TAMAI KNIT FASHION LTD.

141/A, BSCIC Industrial Area, Fatullah, Narayanganj, Bangladesh
(23.625863N, 90.479213E)
01st Sep 2016

Observation

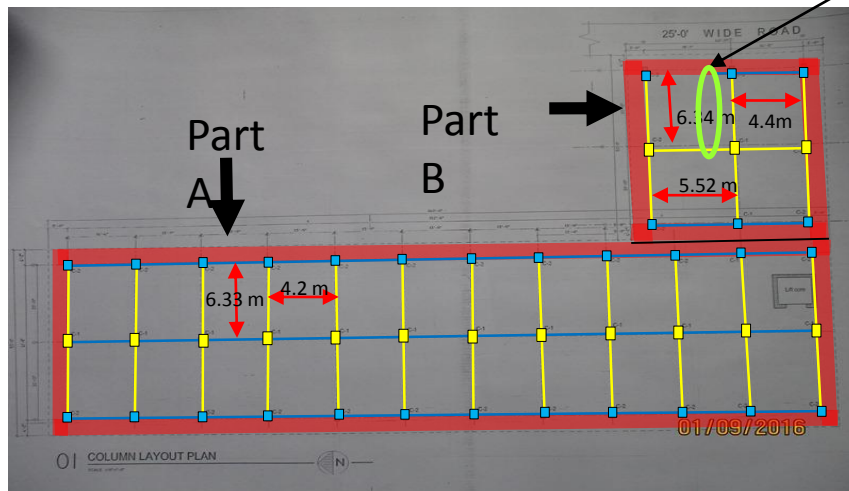
Discrepancy between provided drawing and site condition

Column and beam lay out as per site condition

Provided Column and beam layout

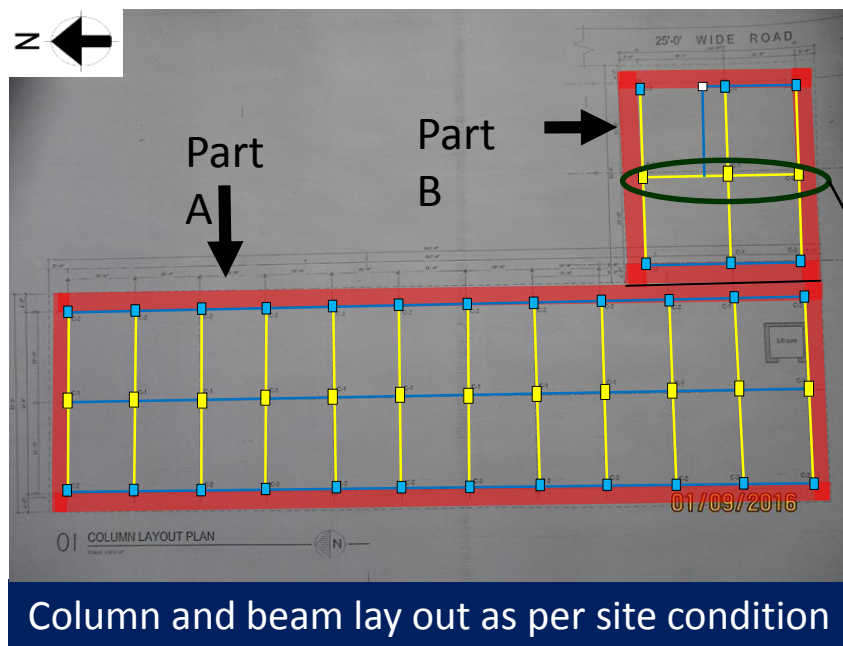
A column with a beam was found adjacent with the stair case which was not shown in provided layout drawing

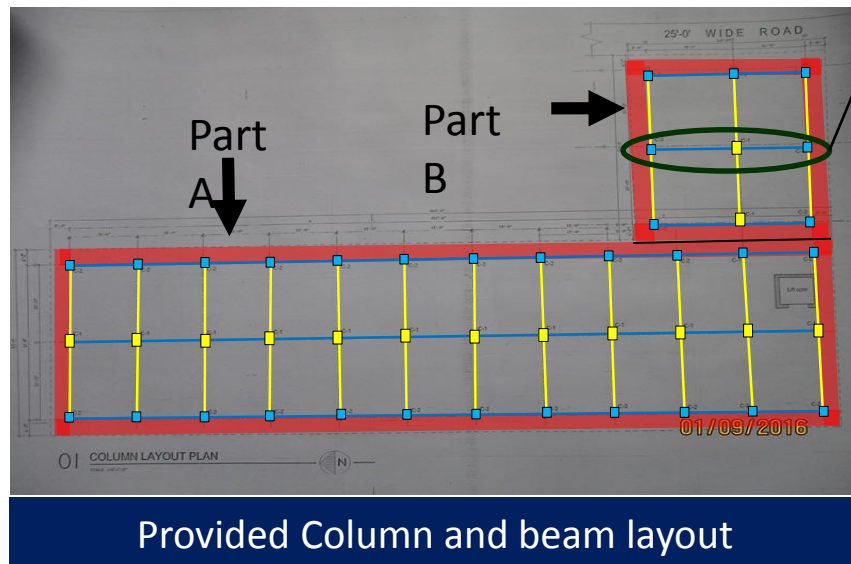
Column and beam lay out as per site condition

Provided Column and beam layout

Provided column and beam schedule didn't match with site condition.

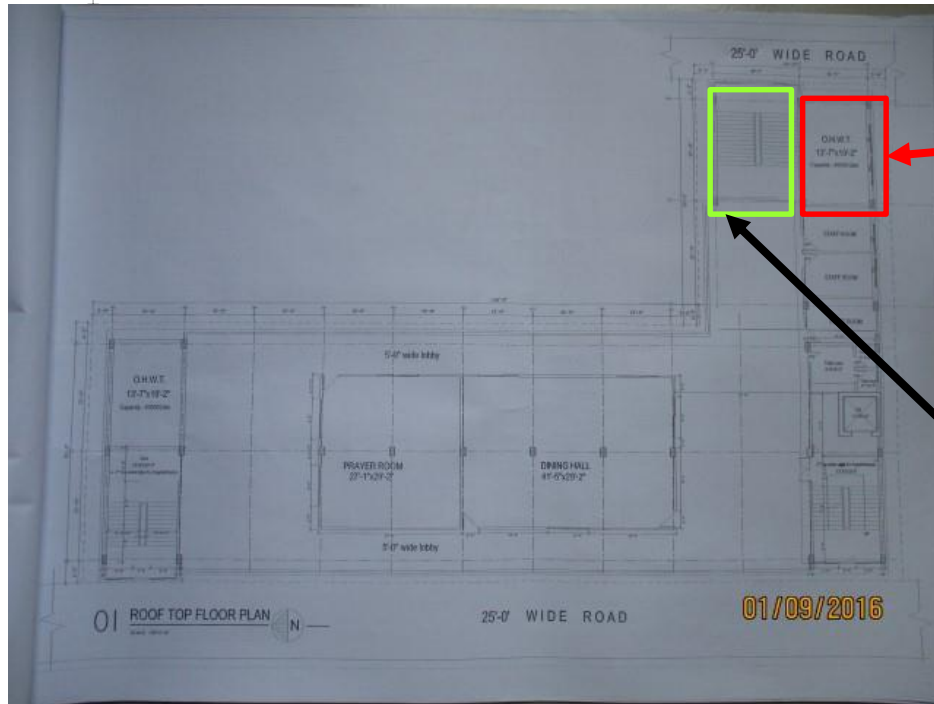
Location of over head water tank on provided architectural drawing.

Observed Location of over head water tank

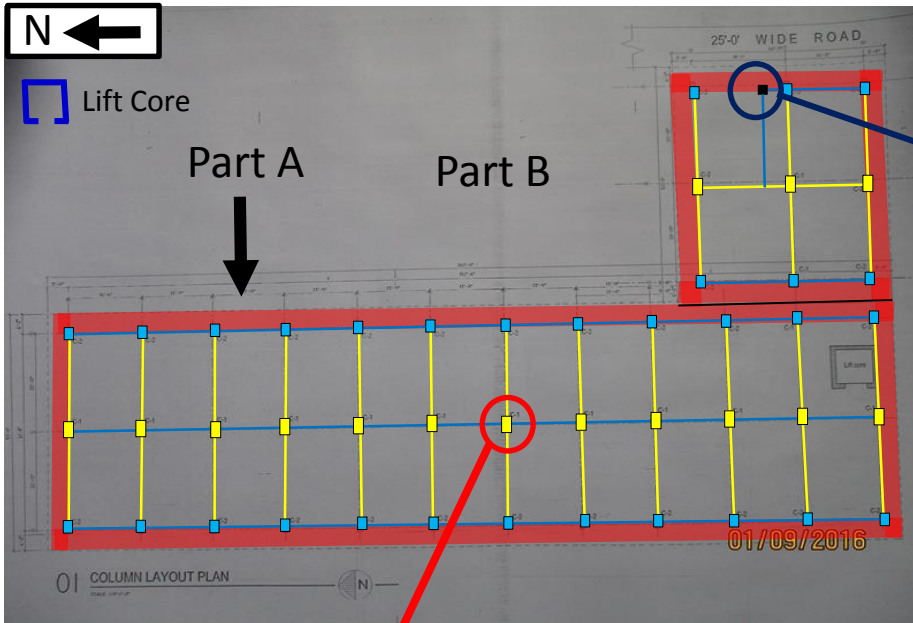
Brick aggregate found in 7th floor on part B and stone aggregate found in all other floor on Part A but aggregate type was mentioned as stone chips for both part A&B in working drawing.

Typical Layout Plan

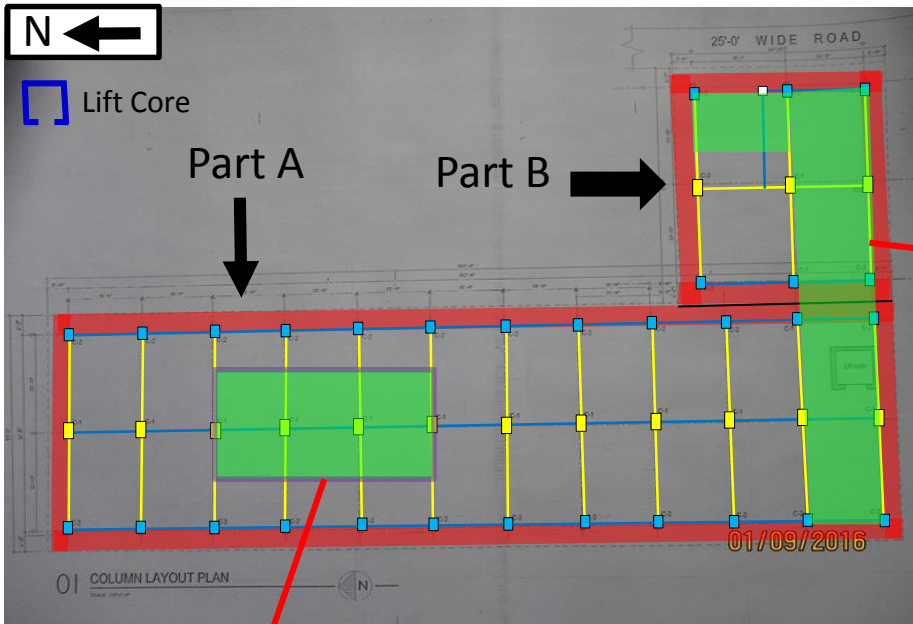
Apparently lack of lateral stability

Building engineer to check lateral stability of the building against lateral load combination for poor aspect ratio . The structural arrangement in tall slender building may result in net tension structural element.

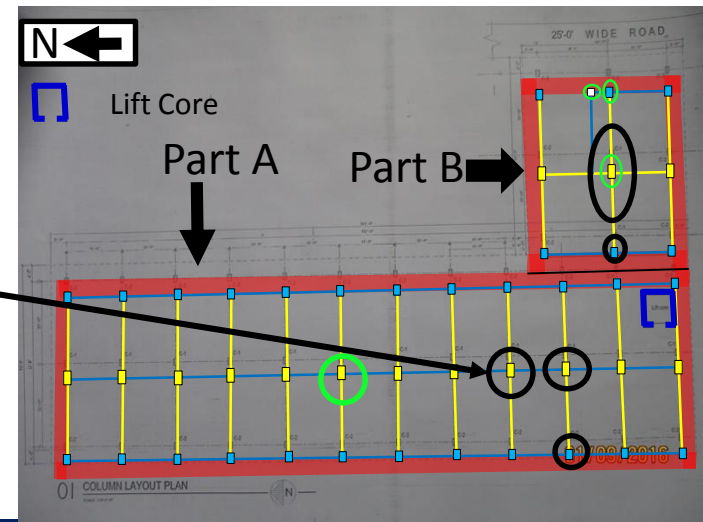
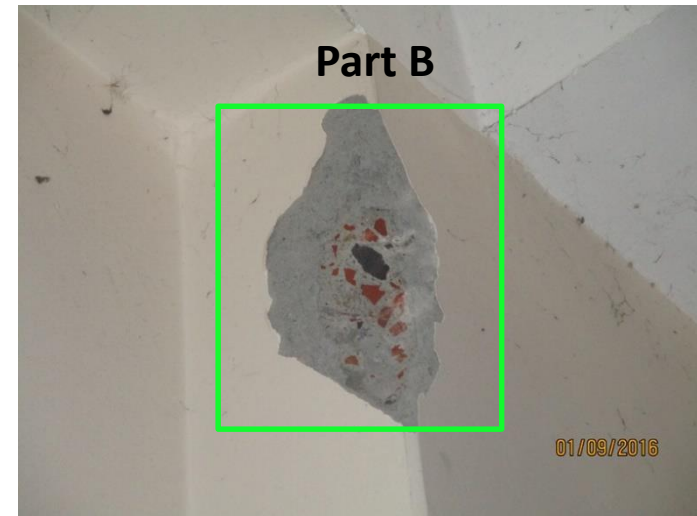
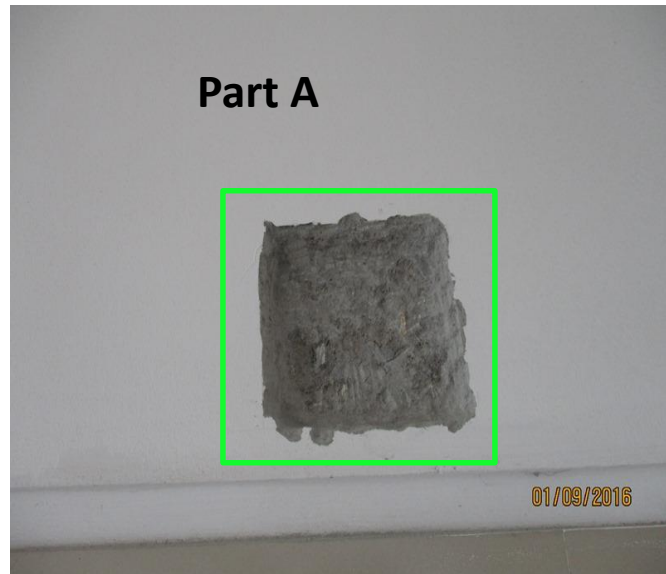
Undocumented extension at roof level

■ Undocumented extensions were found at roof level in both part-A and part-B of the building.

7	Lack of lateral stability	Implement remedial work if required.	6-months
8	Undocumented extension at roof level	Building engineer to review design and column stress considering the extension at roof level.	6-weeks
9	Undocumented extension at roof level	Implement remedial work if required.	6-months
